AGENDA
HISTORIC DISTRICT COUNCIL
REGULAR MEETING
MAY 15, 2025
5:00 PM
CITY HALL COMMISSION CHAMBERS
204 ASH STREET
FERNANDINA BEACH, FL 32034

**MINUTES
HISTORIC DISTRICT COUNCIL
REGULAR MEETING
APRIL 17, 2025
5:00 PM
CITY HALL COMMISSION CHAMBERS
204 ASH STREET
FERNANDINA BEACH, FL 32034**

Site Plan:

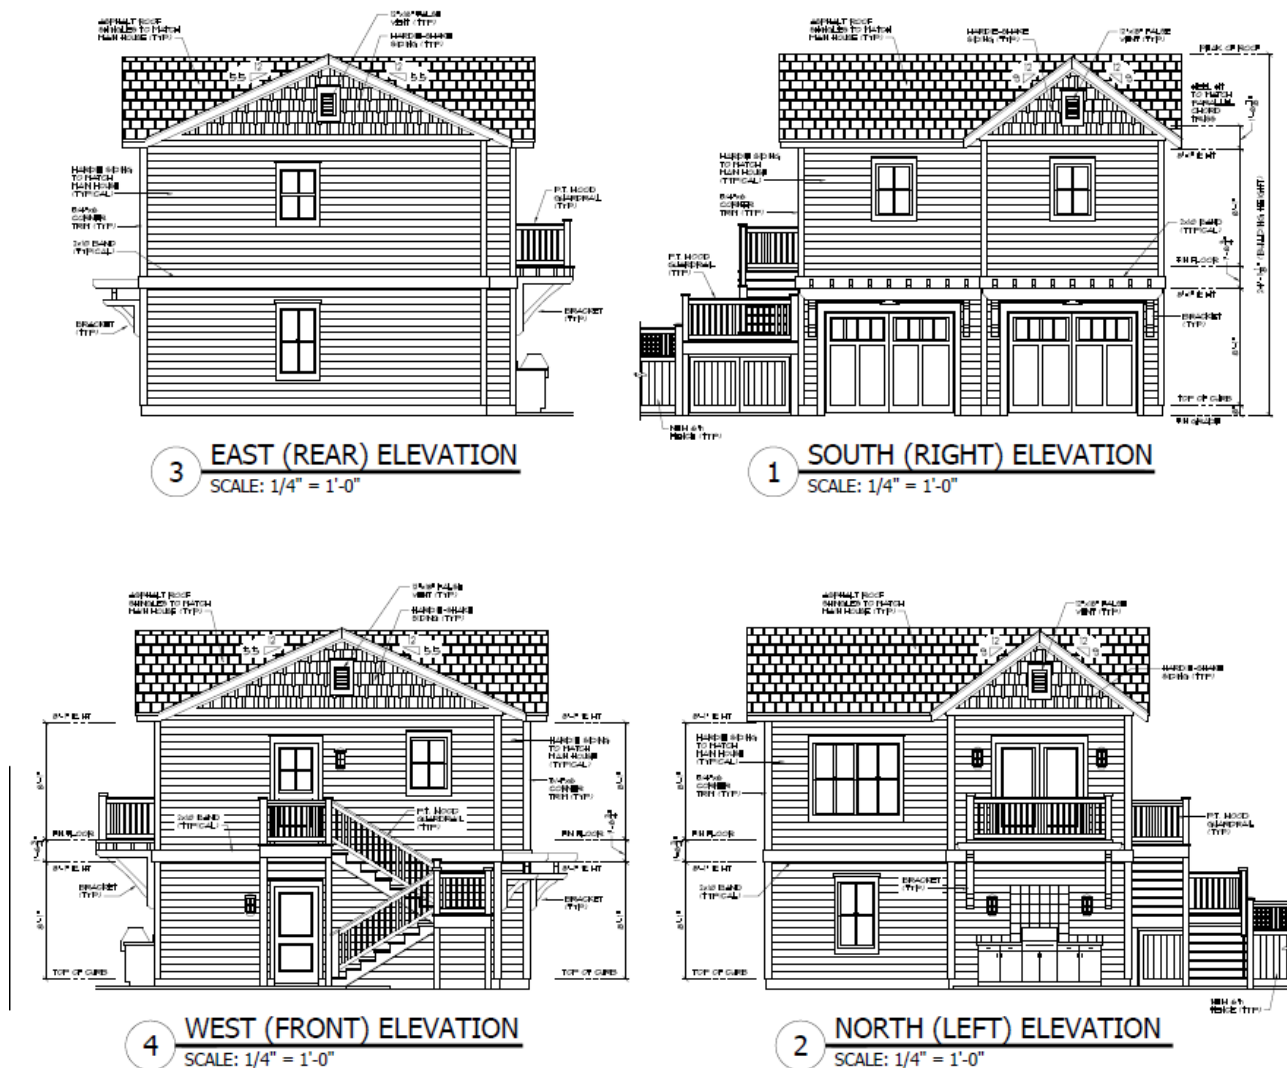
- **Lot Density** – As the property is in the Central Business District, lot coverage may reach 100%.
- **Mechanical** – Per LDC 4.02.03(A)7, *“Mechanical equipment may be located within the side or rear yard setback, but not closer than five (5) feet to side or rear yard lot lines.”* The site plan provides location of pool and mechanical equipment as consistent with dimensional standards.

Staff finds that the requested action, as presented, is consistent with the Comprehensive Plan, the Land Development Code, the Historic District Design Guidelines.

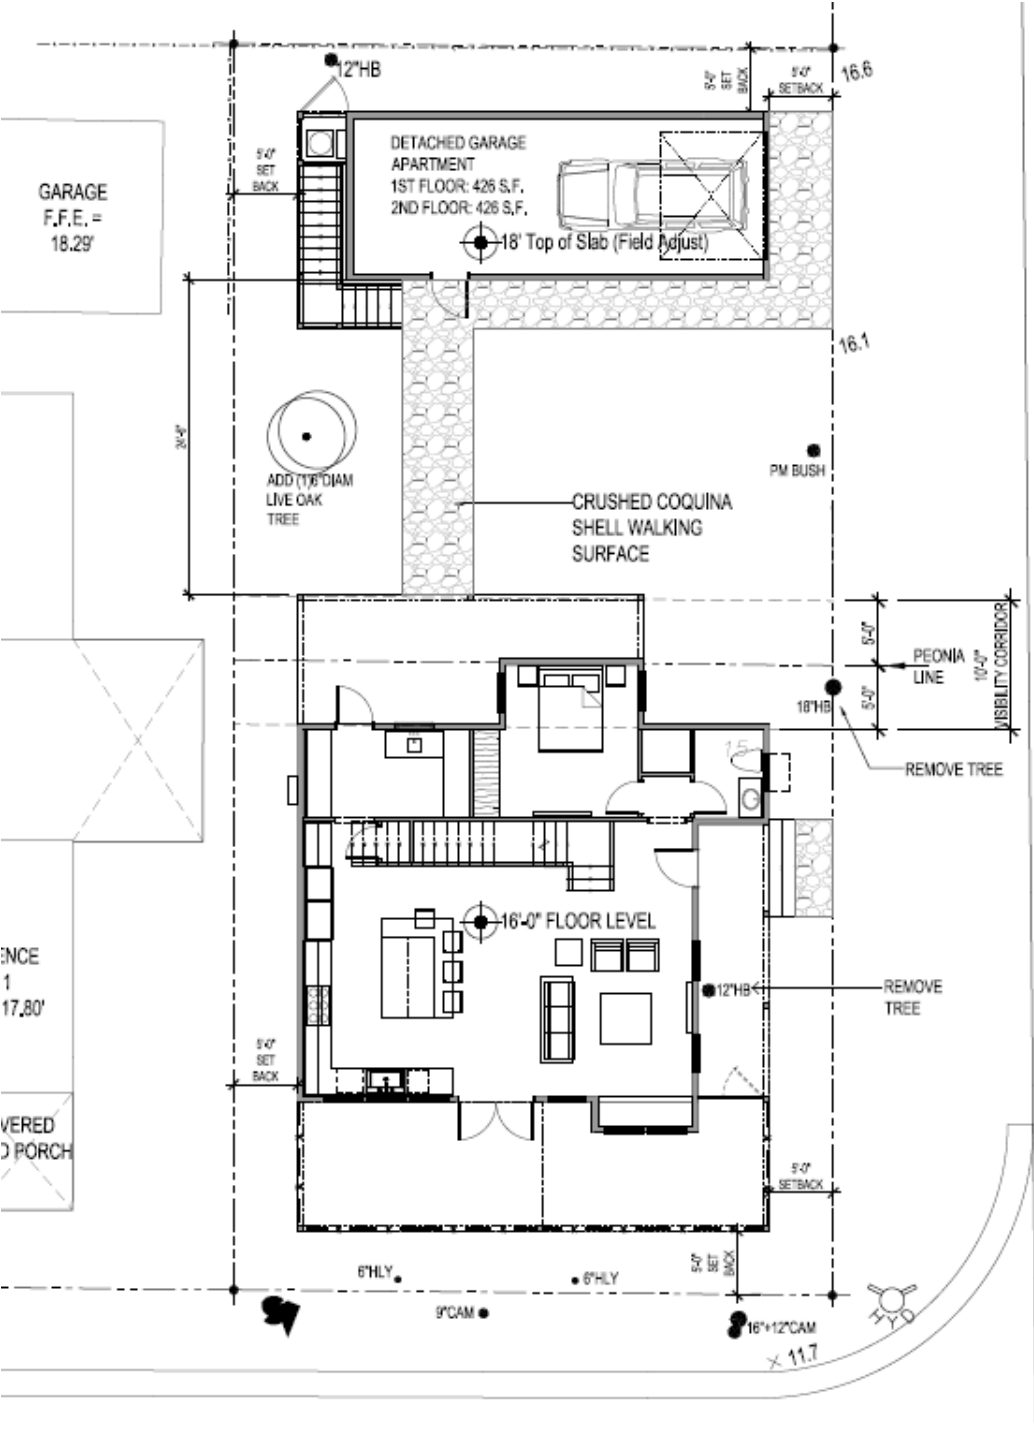
The applicant is returning to HDC to request **Final** Approval to construct a new single-family residence on the vacant lot listed above. They are also seeking approval to build a 2-story ADU with a garage and a living unit on the second floor. The following changes have been made to the plans and application to accommodate the comments received for the HDC on April 17th.

- Design altered to comply with view corridor at peonia line.
- East elevation altered with roof color and line to emphasize roof shape change at roof offset to emphasize view corridor.
- Water table trim detail added at 1st to 2nd floor transition at 2-story tall walls.

- Coquina shell walk surface provided at connecting element between house and accessory building.
- Lot coverage calc provide and meets 45% maximum coverage requirement.

Staff finds that the requested action, since revised from April's HDC meeting, as presented, is consistent with the Comprehensive Plan, the Land Development Code, the Secretary of the Interior's Standards, and the Old Town Fernandina Preservation and Development Guidelines.
